Notice of Intent

Type of Action: APD Change

Procedure Description: XTO respectfully requests approval to make the below listed changes to the approved APDs. 1. Casing design to be changed from the “4-String Design – Engineered Weak Point” (FIGURE F) to the “4-String Design – Open 1st INT x 2nd INT Annulus” (FIGURE D). An open annulus will be utilized and monitored during completions operations. Post completion, bradenhead squeeze will be performed to tie back the 1st intermediate x 2nd intermediate annulus. TOC will be placed into the 1st intermediate shoe but still below the base of Potash interval. 2. No changes to the cementing, casing or mud circulating system designs will be required for the requested change. 3. There is no new surface disturbance. Please refer to the R-111-Q well bore diagrams in the attachment reflecting the changes requested. WELL NAME API Number JRU Apache Federal Com 113H 30-015-55783 JRU Apache Federal Com 803H 30-015-55766 JRU Apache Federal Com 902H 30-015-55854 JRU Apache Federal Com 903H 30-015-55855 There is no new surface disturbance.

JRU Apache Federal Com 113H 30-015-55783

1. Casing design to be changed from the "4-String Design – Engineered Weak Point" (FIGURE F) to the "4-String Design – Open 1st INT x 2nd INT Annulus" (FIGURE D). An open annulus will be utilized and monitored during completions operations.

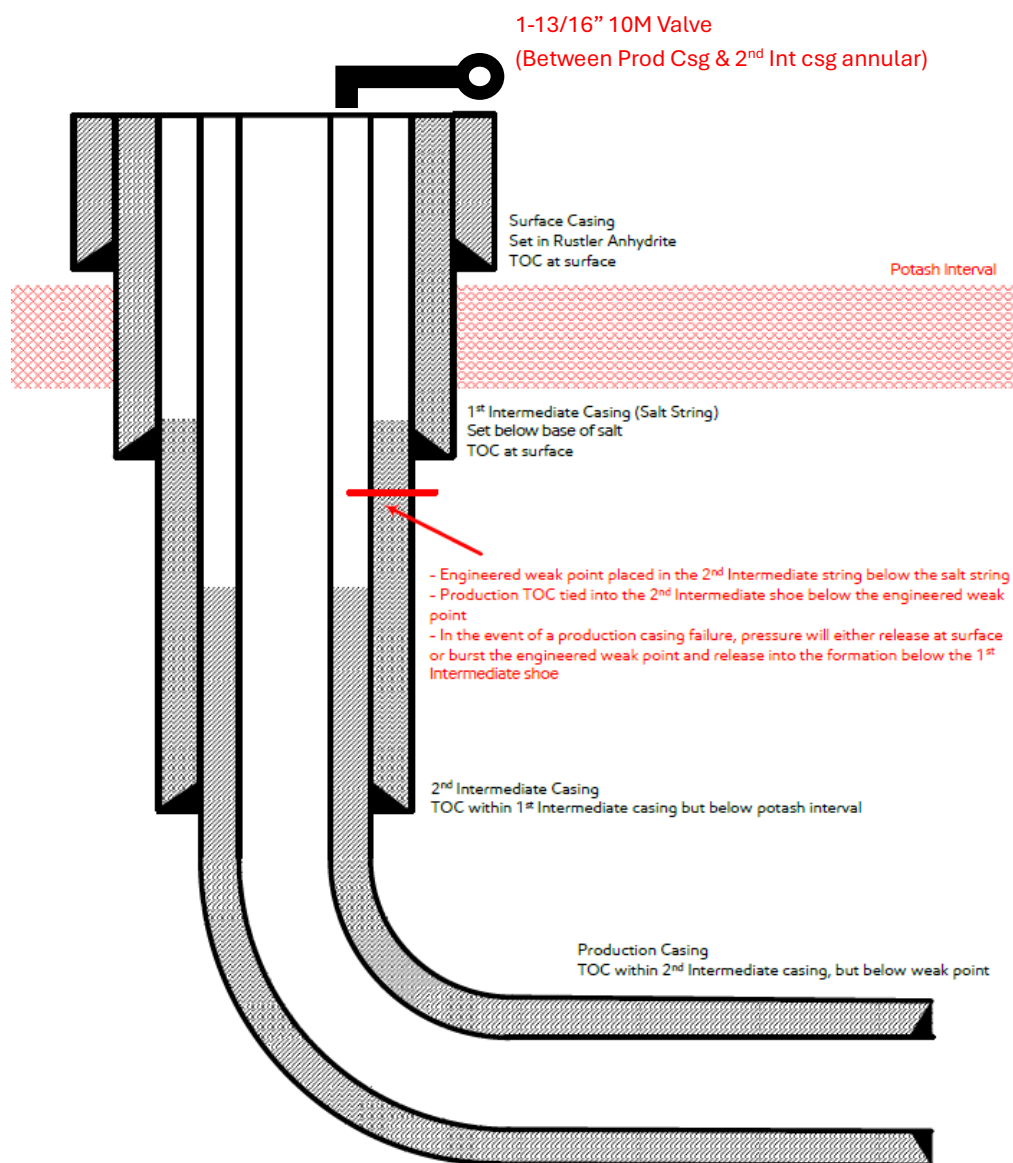
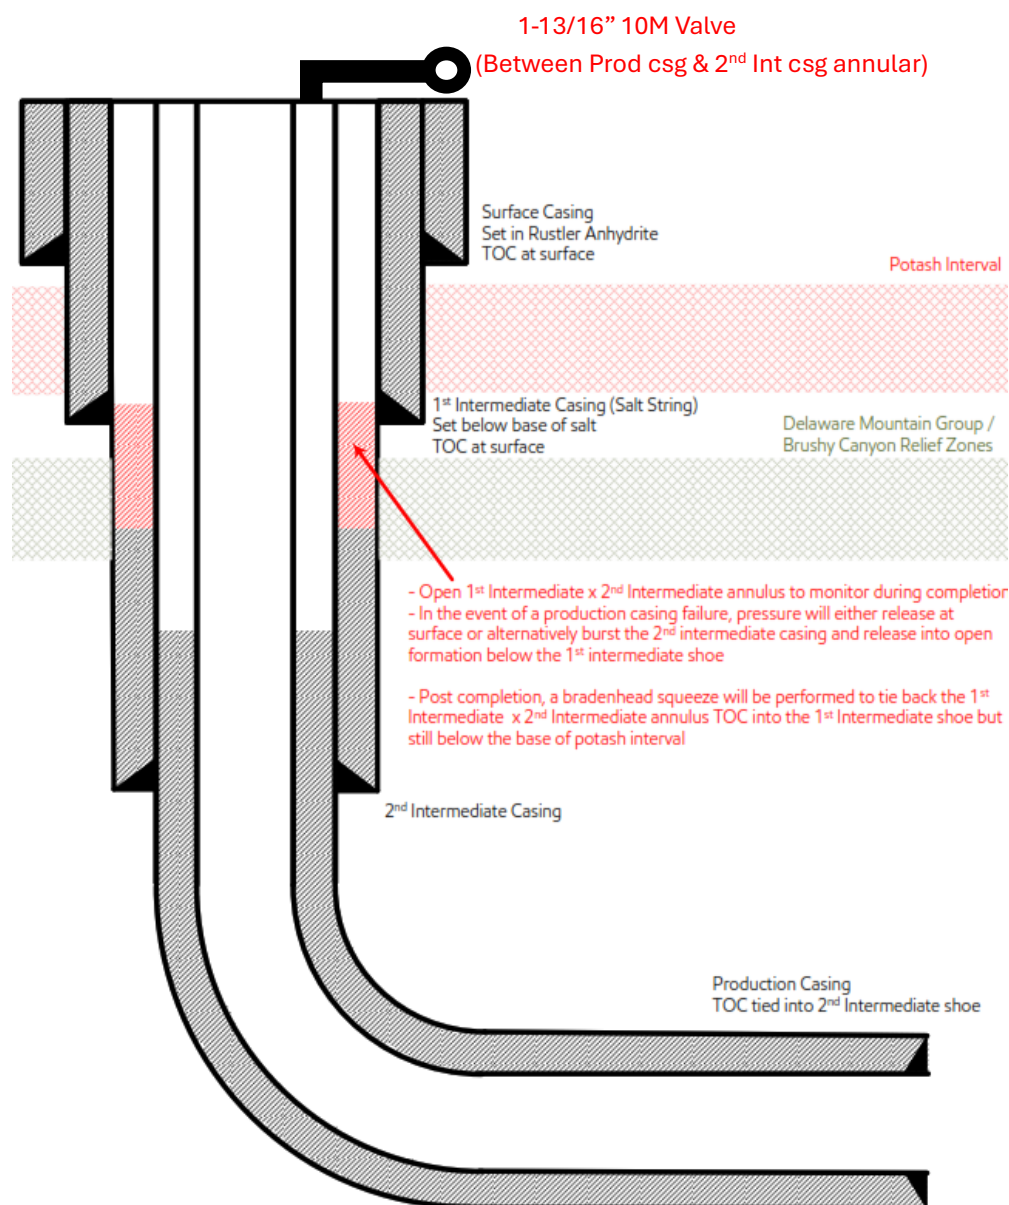
Previous Design: 4-String Design – Engineered Weak Point**[Figure F] 4 String – 2nd Intermediate casing engineered weak point**

- 1) Alignment with KPLA requirements per schematic per schematic below, with engineering weak point casing design and utilizing new casing that meets API standards.
- 2) Contingency plans in place to divert fluids away from salt interval in event of production casing failure.
- 3) Intermediate 2 casing will consist of a primary cement job with TOC at the top of the Brushy Canyon formation within the Delaware Mountain Group.
 - a. Bradenhead squeeze to be completed after primary cement job to tie back TOC to intermediate 1 "Salt string" at least 500' but with top below Marker Bed 126 "Potash Interval".
- 4) Production cement to be tied back no less than 500' inside previous casing shoe (intermediate 2 casing) and below the engineered weak point.

New Proposed Design: 4 – String Design – Open 1st Int X 2nd Int Annulus (ICP 2 below relief zone)**[Figure D] 4 String – Uncemented annulus between 1st and 2nd intermediate casing strings**

- 1) Alignment with KPLA requirements per schematic above, leaving open annulus open for pressure monitoring during frac and utilizing new casing that meets API standards.
- 2) Contingency plans in place to divert fluids away from salt interval in event of production casing failure.
- 3) Intermediate 2 bradenhead squeeze to be completed within 180 days to tieback TOC to salt string at least 500ft but with top below Marker Bed 126.
- 4) Production cement to be tied back no less than 500ft inside previous casing shoe.

Post completion, bradenhead squeeze will be performed to tie back the 1st intermediate x 2nd intermediate annulus. TOC will be placed into the 1st intermediate shoe but still below the base of Potash interval.

2. No changes to the cementing, casing or mud circulating system designs will be required for the requested change.
